Fast-track Approvals Act 2024

MINUTE 12 OF THE EXPERT PANEL

Request for comment on draft conditions
Drury Metropolitan Centre [FTAA-2502-1019]

21 October 2025

Scheme plan (Stage 2.6.1) – showing arrangement of Lots 603 – 605

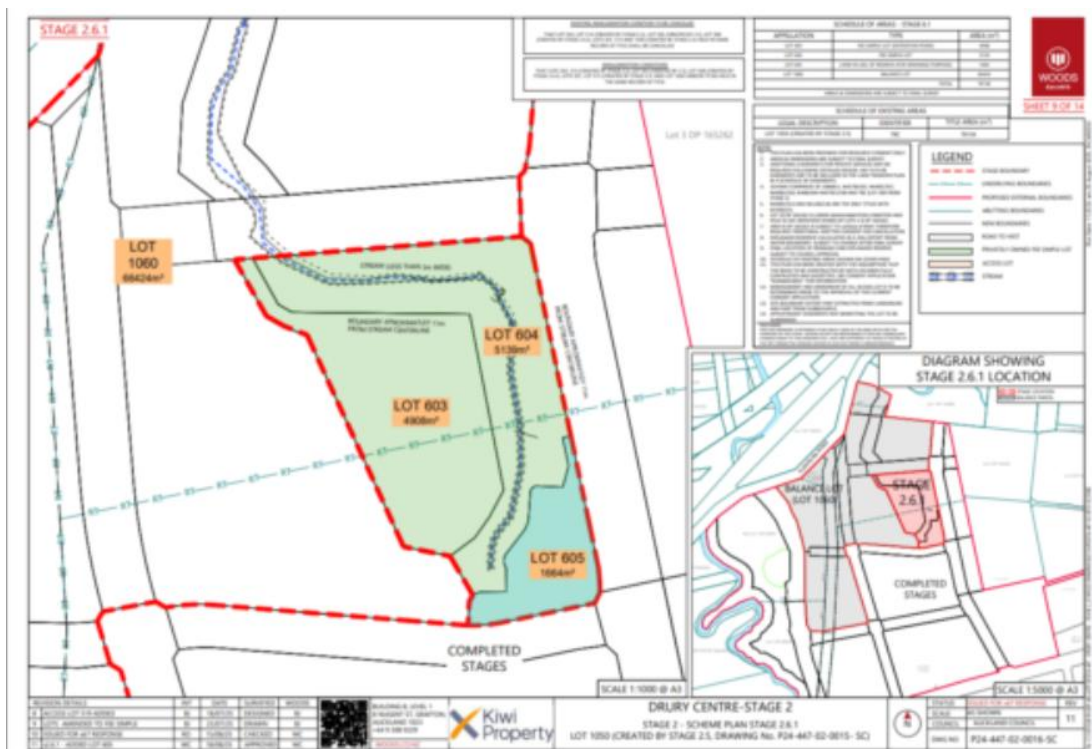
- [16] The last row of the table (left column) within Condition 10 refers to a private raingarden within Lot 605 (amended from Lot 604), which reflects the updated scheme plan for Stage 2.6.1 provided with the Applicant's "Response to Comments" dated August 2025 (Attachment 15 – Key Plans Package). In reviewing the updated clause and the subdivision plans of 18 August 2025 relating to Wetland 2-2, the Panel questions whether the delineation of this area as "Lot 604" (Woods Drawing P24-447-01-3003-DR) is accurate, noting that this is the same lot reference for the location of Wetland 2-1. Scheme plan P24-447-02-0013-SC shows this area as 'Area A' (new easement to be created), within Lot 600. We note there is no reference to Lot 604 within SUB

- a) the condition should also incorporate the raingarden proposed for Lot 605; and
- b) a corresponding condition in respect of Wetland 2-2 in easement Area 1 (or "Lot 604" as noted at [16] above) should be included as part of the Stage 2.3 condition.

Engineering and scheme plan drawings (see [16] above)

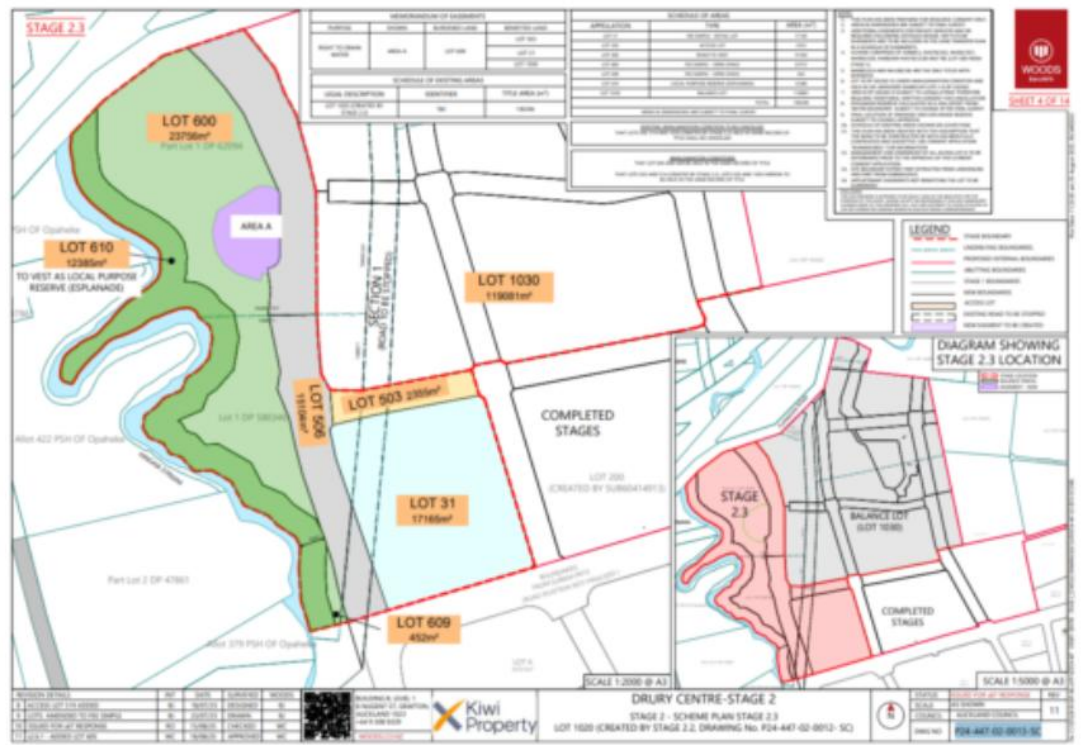
[17] Further to [16] above relating to the public or private ownership of Wetlands 2-1 and 2-2, the Panel's stormwater expert Nigel Mark-Brown has noted that, contrary to the agreements at expert conferencing (reflected in the JWS), the new Woods Drawing P24-447-01-3003-DR of 7 October 2025 appears to show:

- a) the discharge pipes from the private wetlands to be public rather than private (refer Outlet 'AB-03' [Wetland 2-1] and 'Outlet/02 [Wetland 2-2]); and
- b) the discharge pipe from the raingarden to be private (refer unlabelled outlet shown at south end of the raingarden).

If this change is intended, the Panel considers that this should also be addressed by way of an amendment to the Woods Drawing P24-447-01-3003-DR. This matter is highlighted in the condition set to enable any updates to be made to this drawing reference. Alternatively, a new condition (DIS Condition 11) has been included in the draft conditions. This can be removed from the final conditions if an updated drawing is provided by the Applicant.
